REQUEST FOR PROPOSALS "RFP" NO. PS20180157
LANDSCAPE CONSULTING SERVICES FOR WATER SPRAY PARKS
AT CONNAUGHT AND ROSS PARKS

QUESTIONS AND ANSWERS NO. 1

ISSUED ON March 9, 2018

SHEET TITLE
SITE PLAN & SERVICES

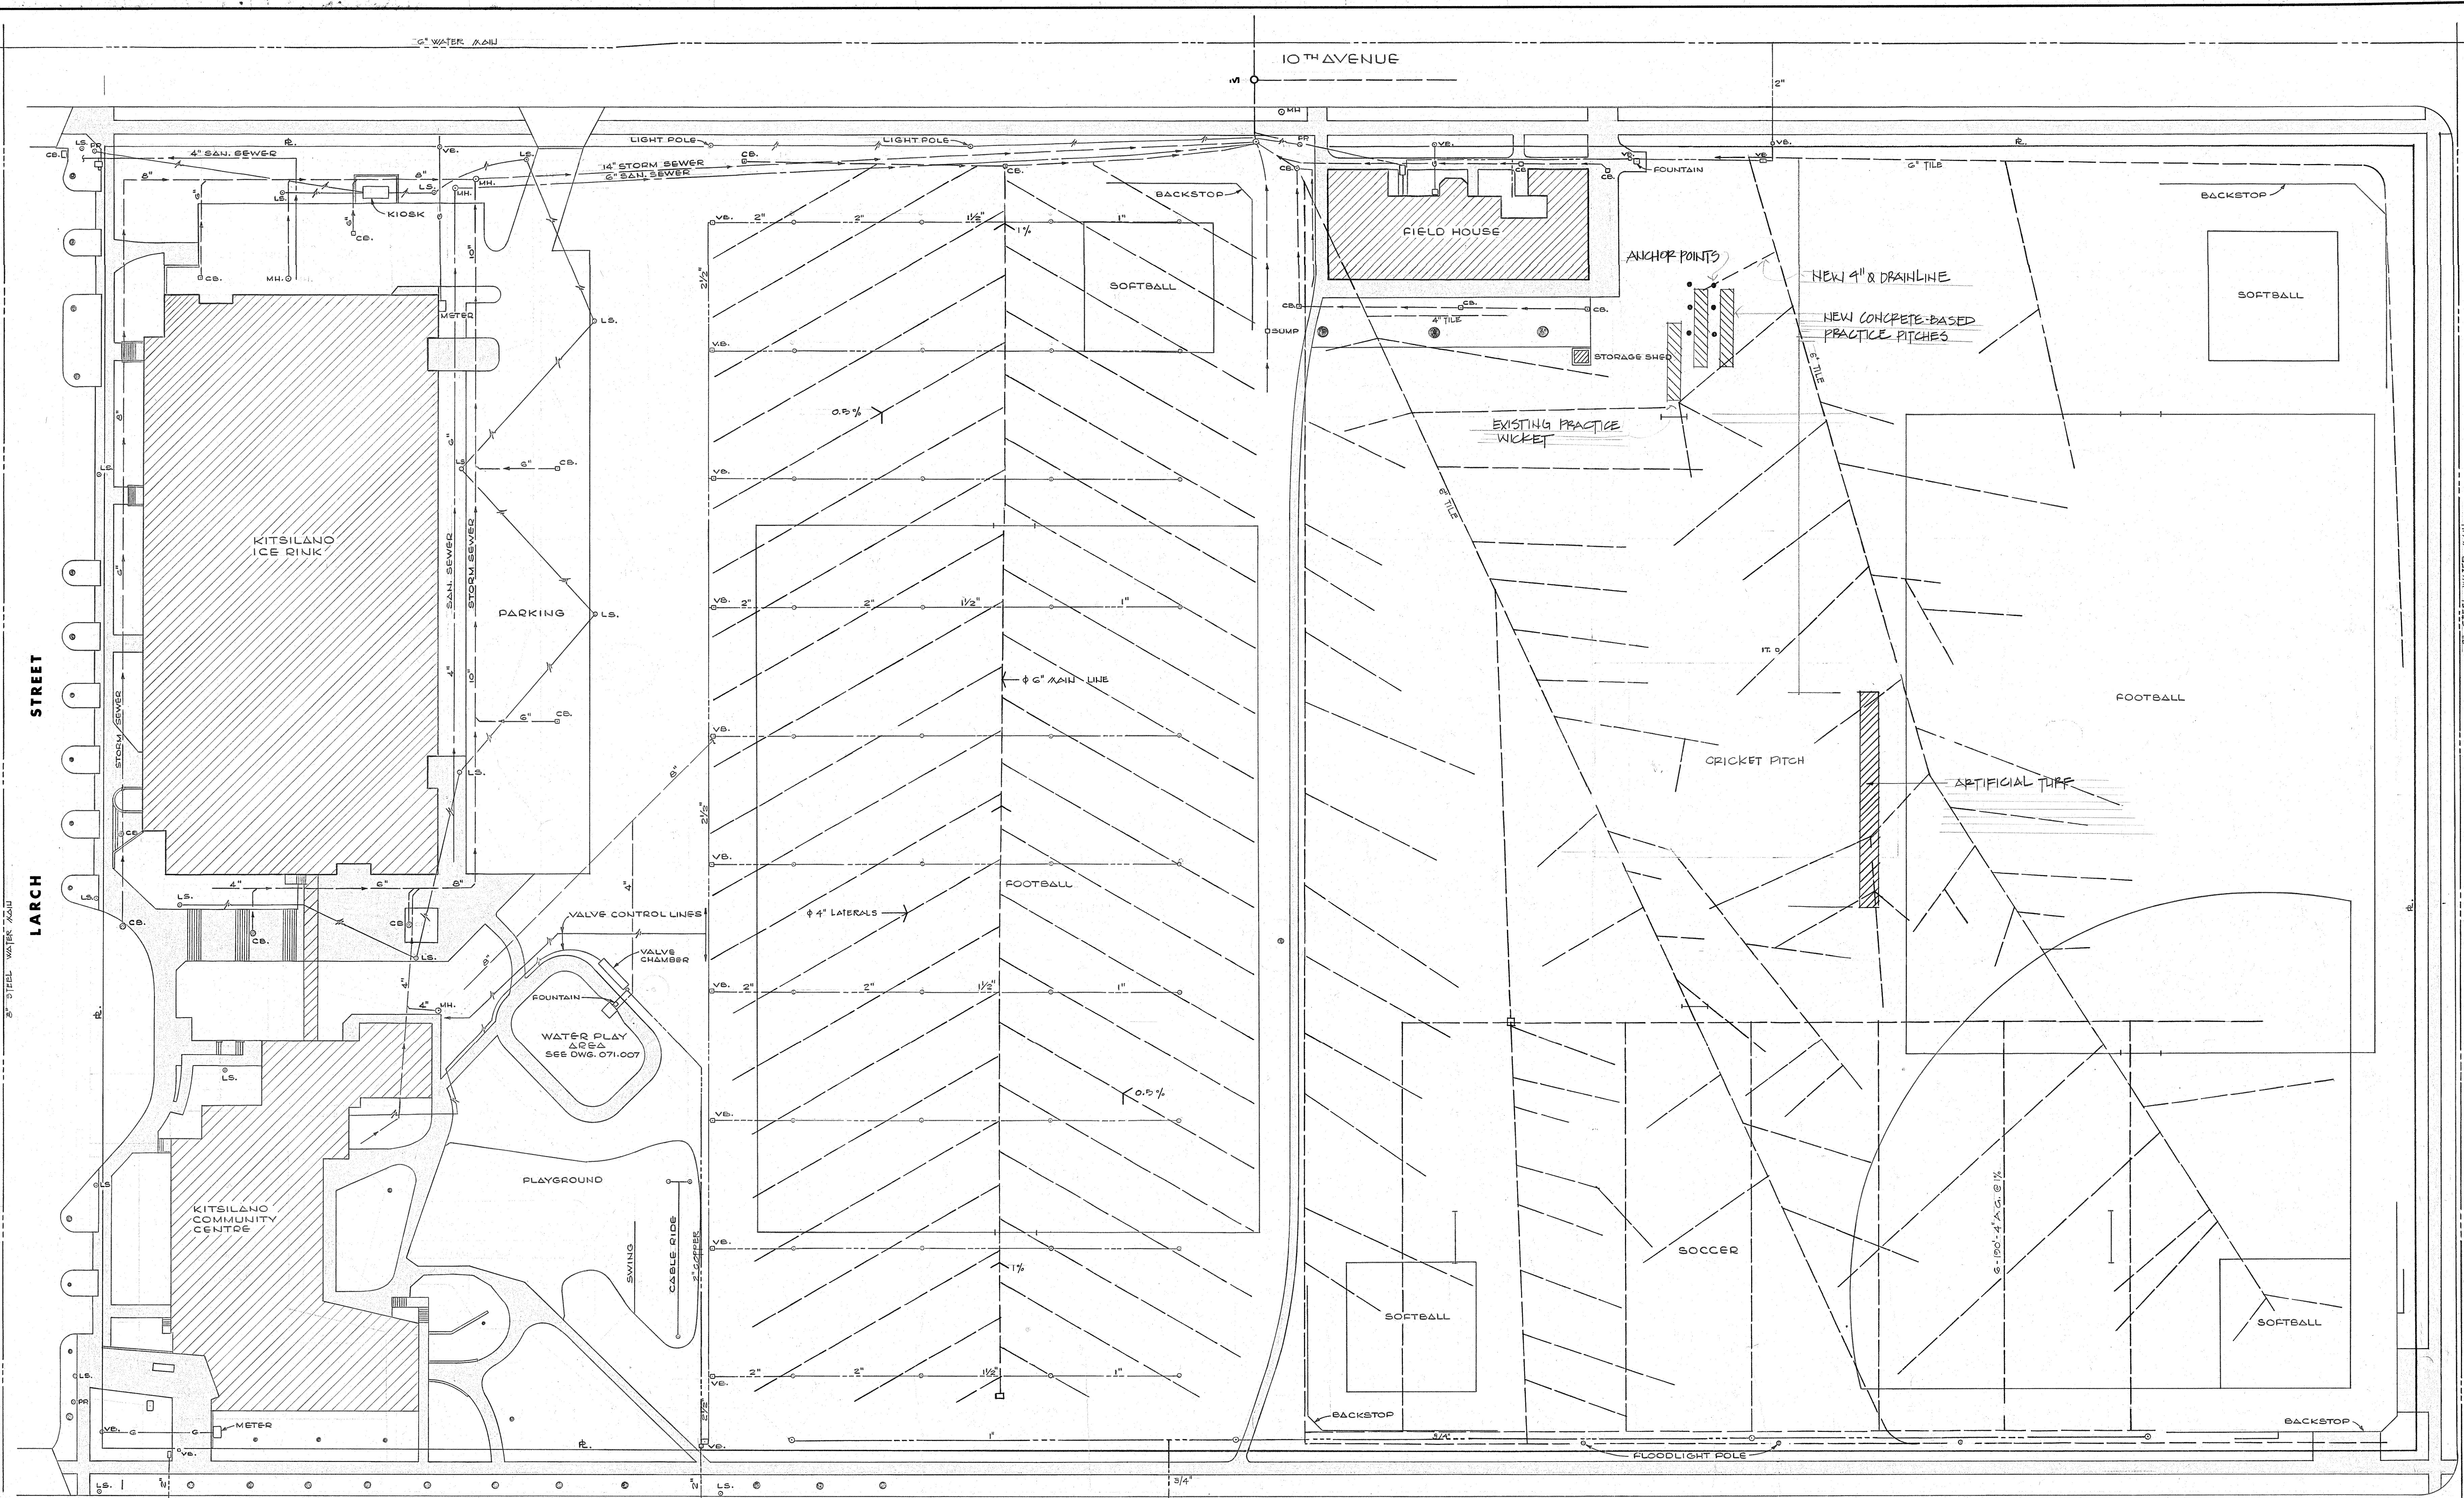
| Q5 | <i>Do you have any information or drawings regarding existing services such as electrical, water, storm and sanitary?</i> |

| Q15 | <i>Where is the electrical system? Is there a control room?</i> |

| A5 | See attached site services plans for reference. |

| A15 | It is anticipated that the Ross Park controller will be located in the fieldhouse and tied into the existing electrical system in the fieldhouse. The controller location for the new spray park at Connaught will remain in the Community Centre. For additional information, see attached site services plan for both parks. |
